MEMORANDUM

Preliminary Plan of Subdivision

PROJECT NAME: Great Falls Estates

120080200

Attachment B

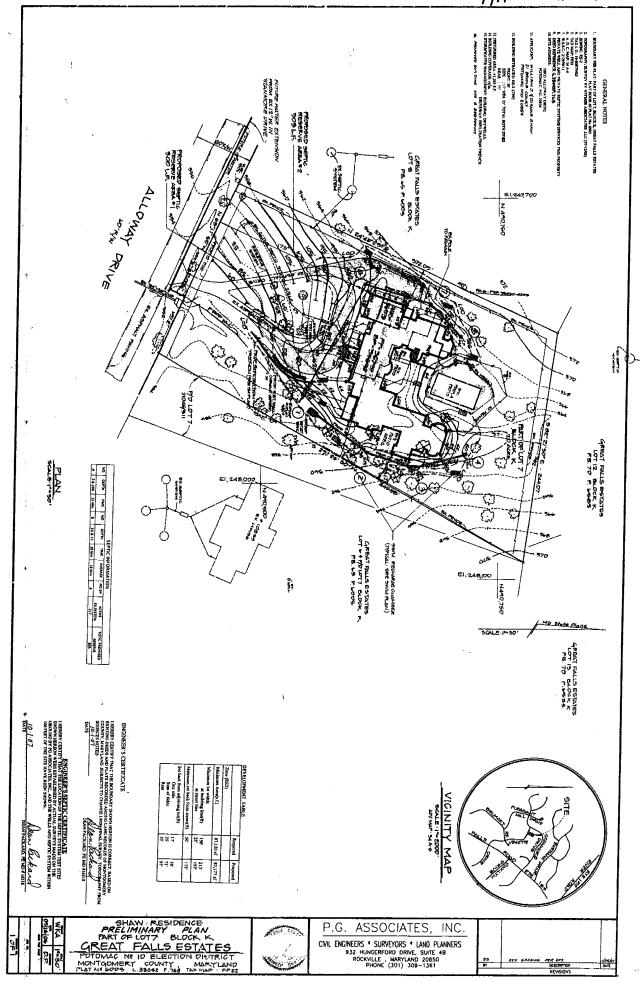
The applicant proposes to resubdivide the Subject Property and create one lot for one one-family detached dwelling unit. The proposed lot is 2.00 acres in size, and is served by public water, and a private standard septic system. The applicant is proposing to demolish the existing dwelling unit and rebuild on the property.
